Well Name: POKER LAKE UNIT 29 BS	Well Location: T25S / R31E / SEC 29 / SENW / 32.101863 / -103.802491	County or Parish/State: EDDY / NM
Well Number: 208H	Type of Well: OIL WELL	Allottee or Tribe Name:
Lease Number: NMNM0157756A	Unit or CA Name: POKER LAKE UNIT	Unit or CA Number: NMNM71016X
US Well Number:	Operator: XTO PERMIAN OPERATING LLC

Notice of Intent

Type of Action: APD Change

XTO Permian Operating, LLC. respectfully requests approval to make the following changes to the approved APD. Changes to include FTP, LTP, BHL, Proposed total Depth. There is no new surface disturbance.

ACREAGE DEDICATION PLATS

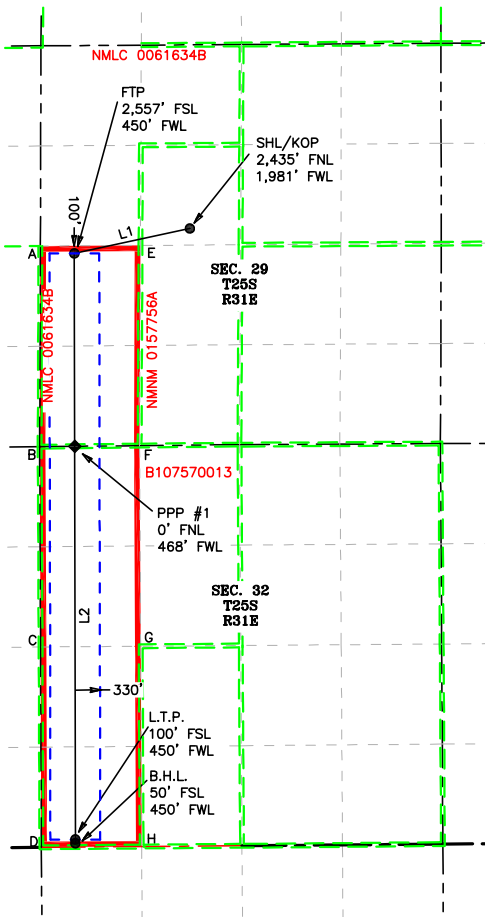
FTP: 2435' FNL & 1650' FWL OF SECTION 29-T25S-R31E 2557' FSL & 450' FWL OF SECTION 29-T25S-R31E

LTP: 100' FSL & 1650' FWL OF SECTION 32-T25S-R31E 100' FSL & 450' FWL OF SECTION 32-T25S-R31E

BHL: 50' FSL & 1650' FWL OF SECTION 32-T25S-R31E 50' FSL & 450' FWL OF SECTION 32-T25S-R31E

The proposed total depth is changing from 19410 MD; 10919 TVD to 18640 MD; 10147 TVD.
